GENERAL NOTES

- ALL ITEMS SHOWN ON THE PLANS AS EXISTING ARE SHOWN IN APPROXIMATE LOCATIONS ONLY. ACTUAL LOCATIONS MAY VARY FROM THE PLANS. REFER TO UTILITY NOTE 1. WHENEVER CONTRACTOR DISCOVERS A DISCREPANCY IN LOCATIONS, HE SHALL CONTACT THE ENGINEER IMMEDIATELY.

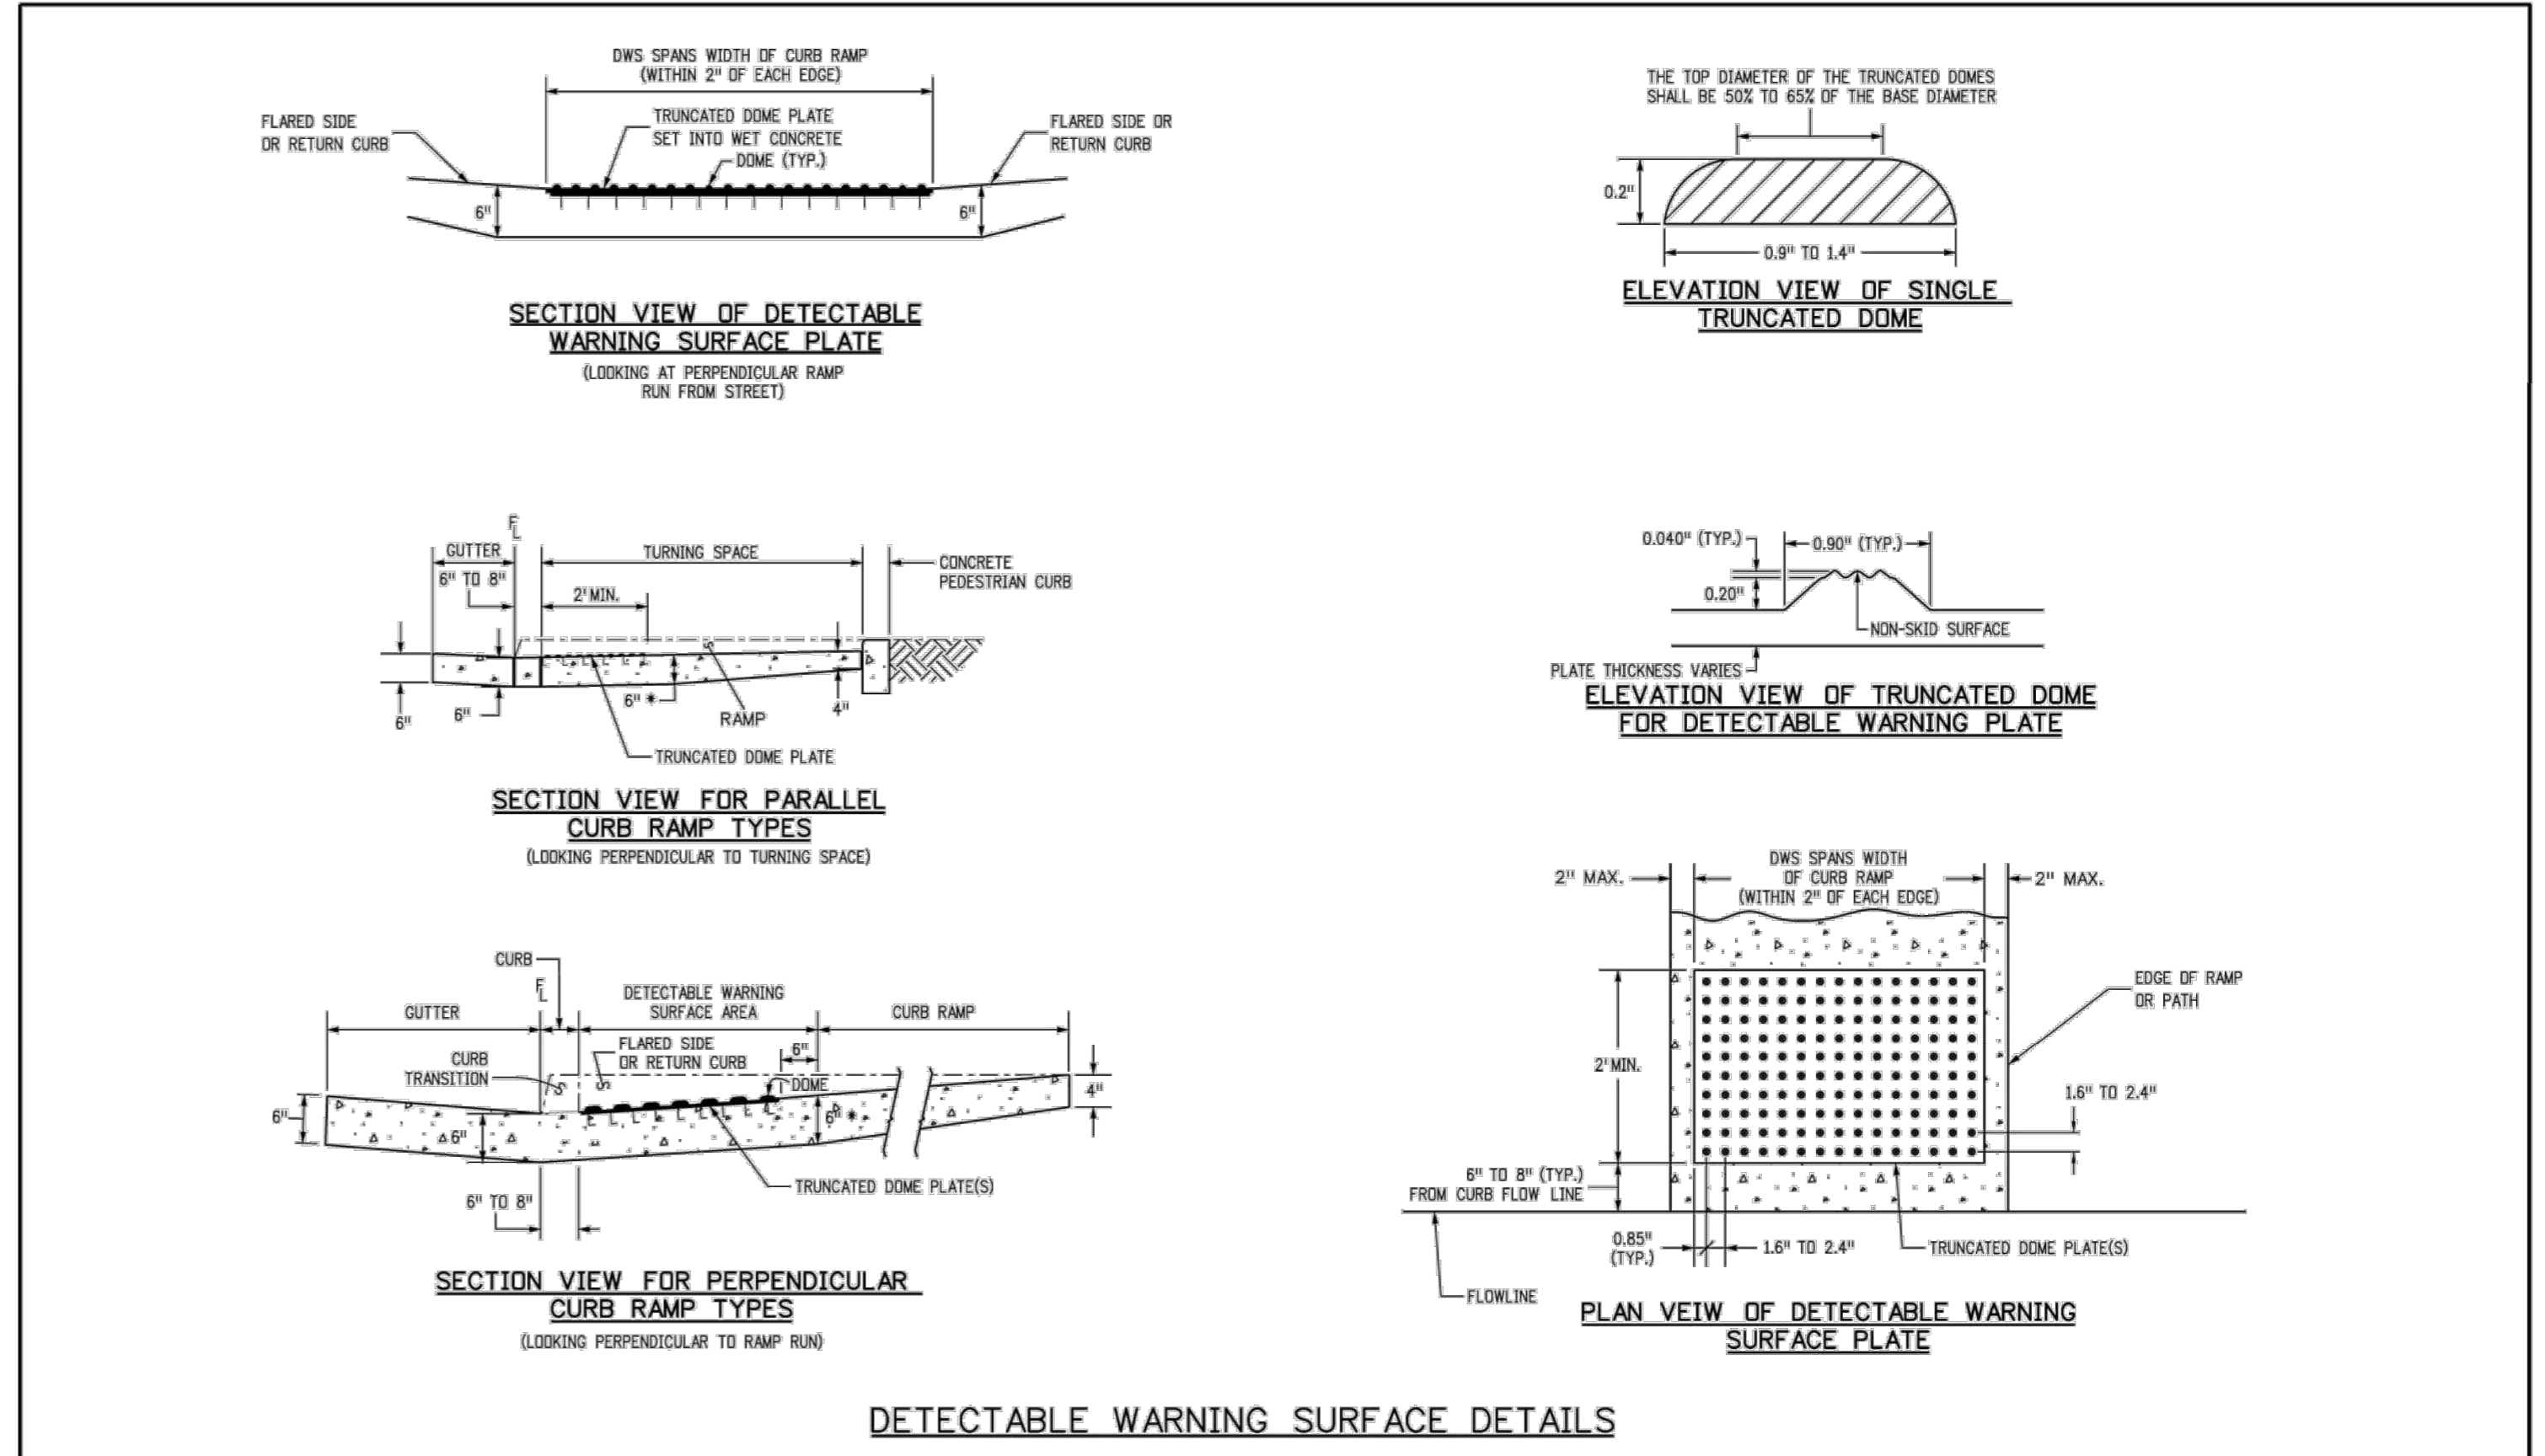
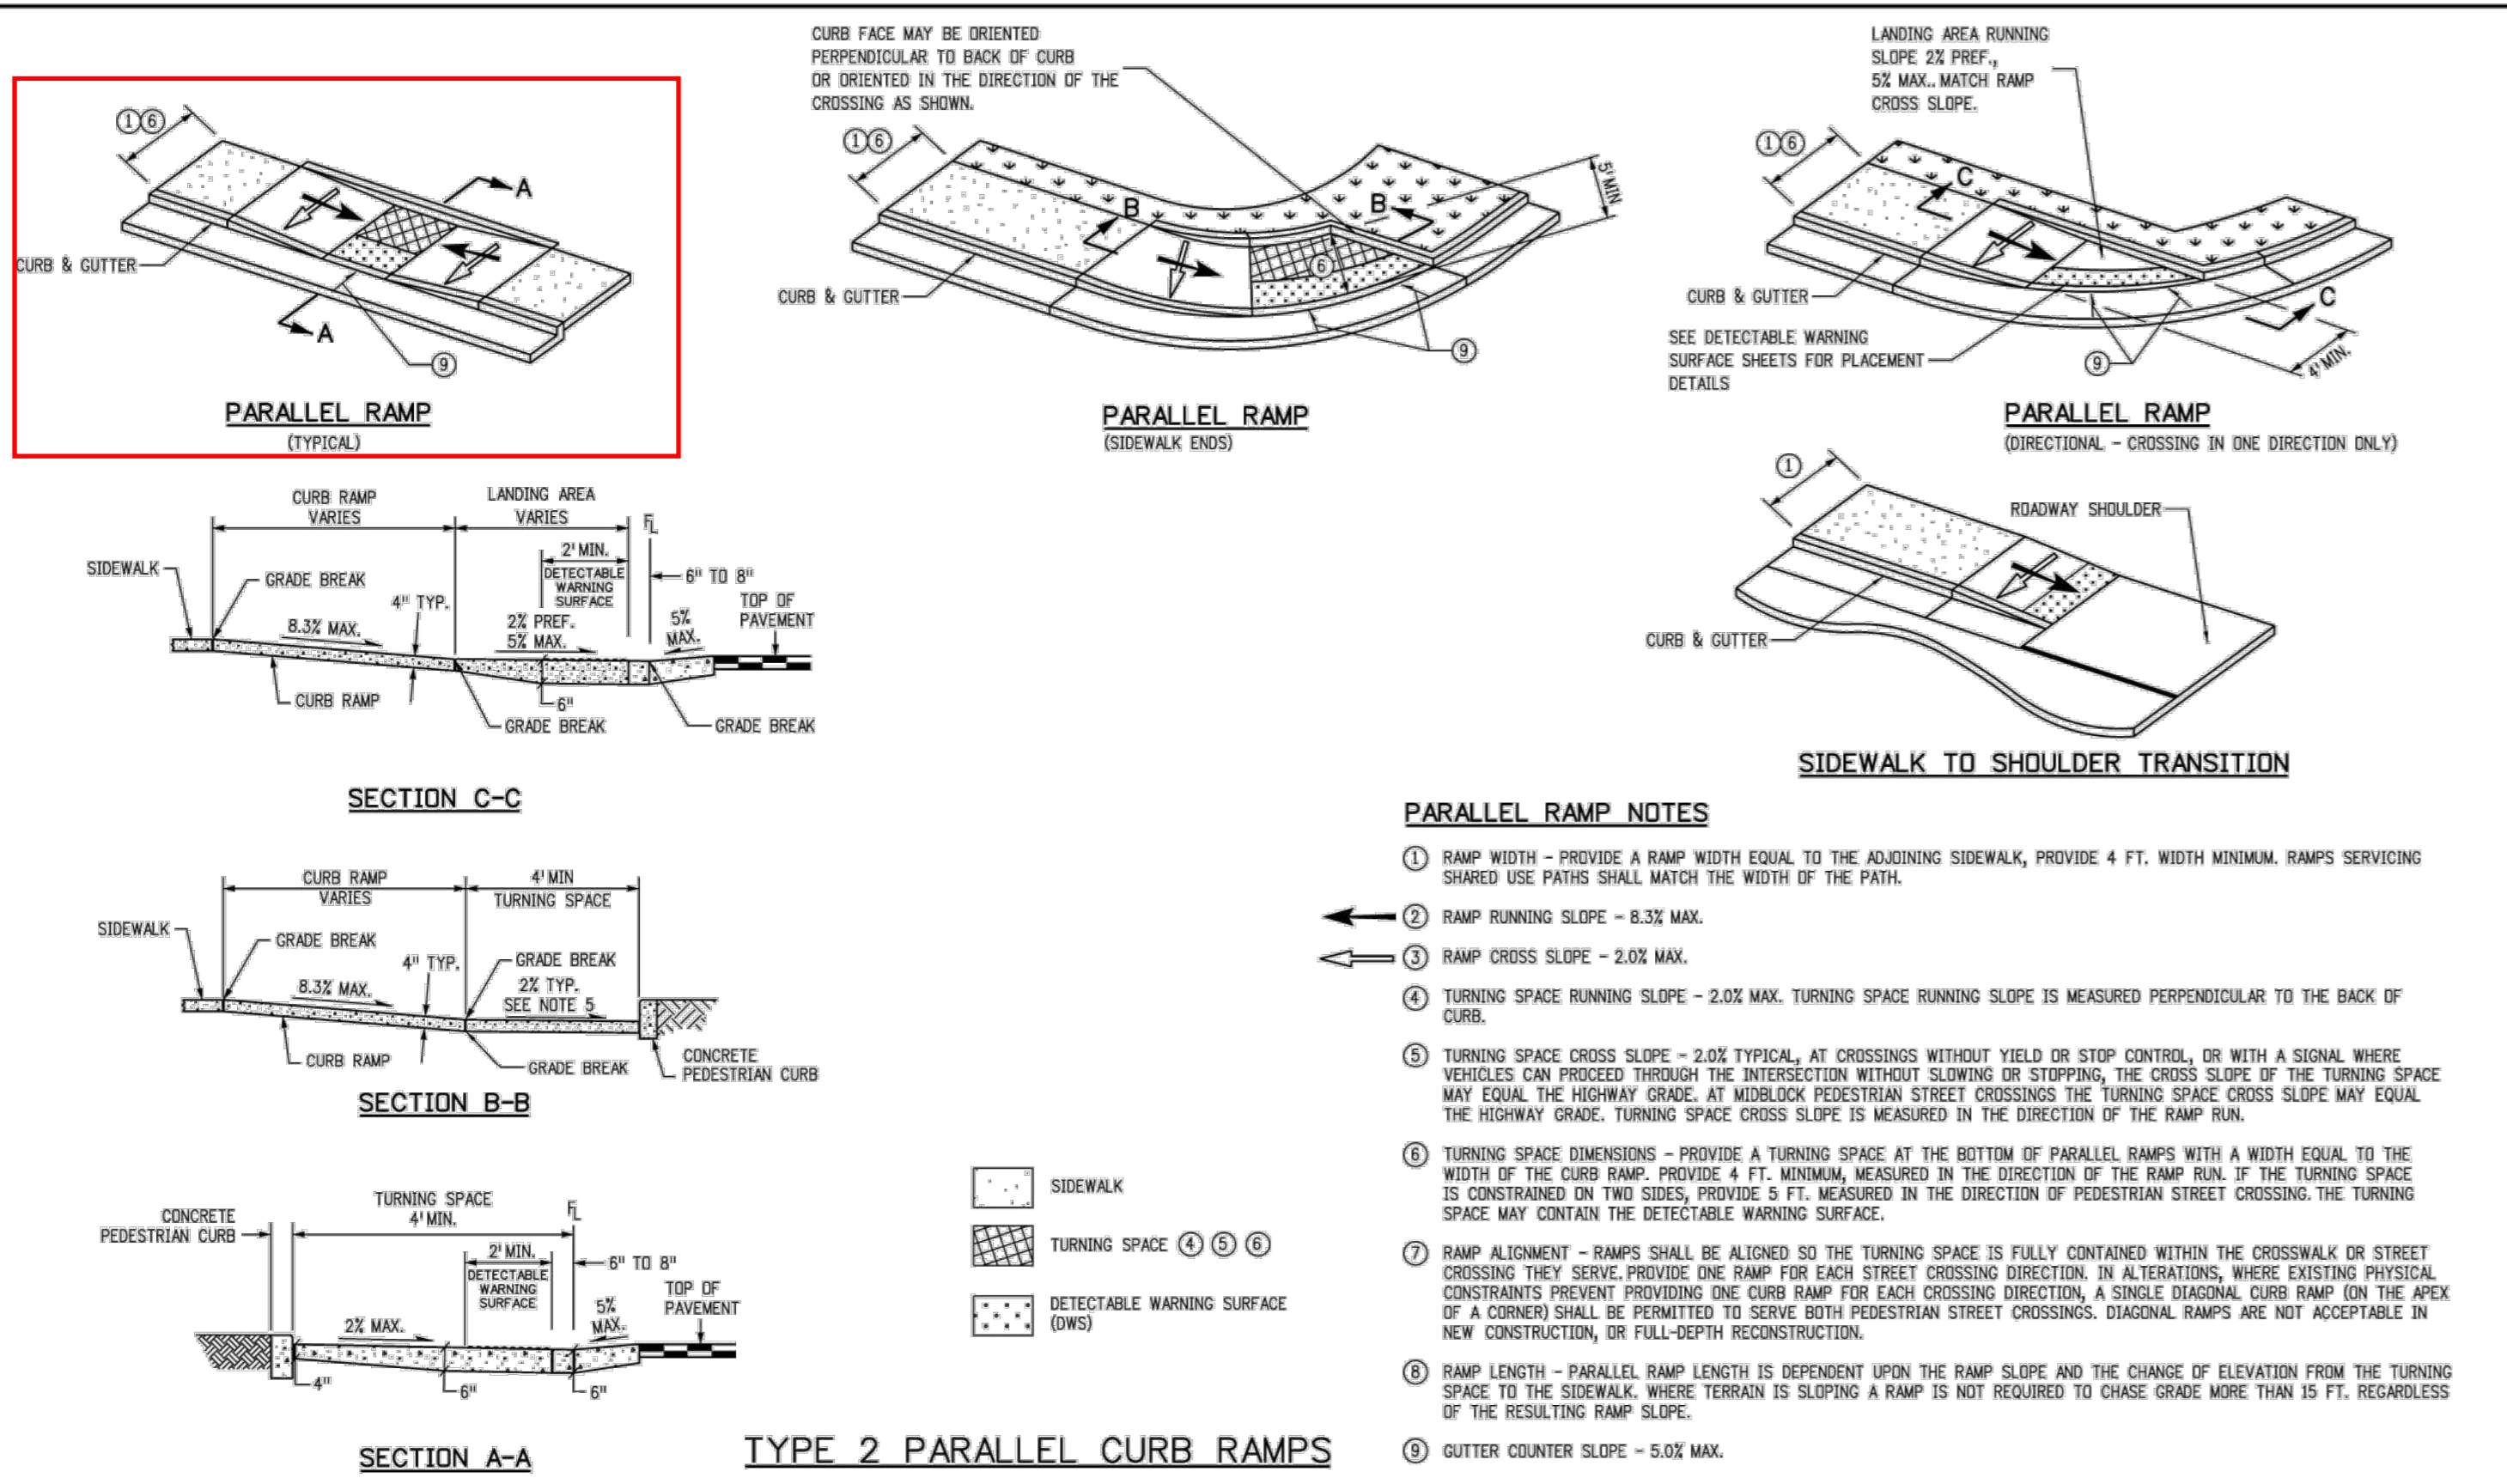
Computer File Information		Sheet Revisions		Colorado Department of Transportation		STANDARD PLAN NO.	
Creation Date: 07/31/19	Designer Initials: JBK	Date:	Comments:	2829 West Howard Place		M-608-1	
Last Modification Date: 07/31/19	Detailer Initials: LTA			C201 HQ, 3rd Floor		Standard Sheet No. 4 of 10	
CAD Ver: MicroStation V8	Scale: Not to Scale			Denver, CO 80204		Project Sheet Number:	
	Units: English			Phone: 303-757-9021 FAX: 303-757-9868		Issued by the Project Development Branch July 31, 2019	
				Project Development Branch		Project Development Branch	
				JBK		JBK

Computer File Information		Sheet Revisions		Colorado Department of Transportation		STANDARD PLAN NO.	
Creation Date: 07/31/19	Designer Initials: JBK	Date:	Comments:	2829 West Howard Place		M-608-1	
Last Modification Date: 07/31/19	Detailer Initials: LTA			C201 HQ, 3rd Floor		Standard Sheet No. 10 of 10	
CAD Ver: MicroStation V8	Scale: Not to Scale			Denver, CO 80204		Project Sheet Number:	
	Units: English			Phone: 303-757-9021 FAX: 303-757-9868		Issued by the Project Development Branch July 31, 2019	
				Project Development Branch		Project Development Branch	
				JBK		JBK
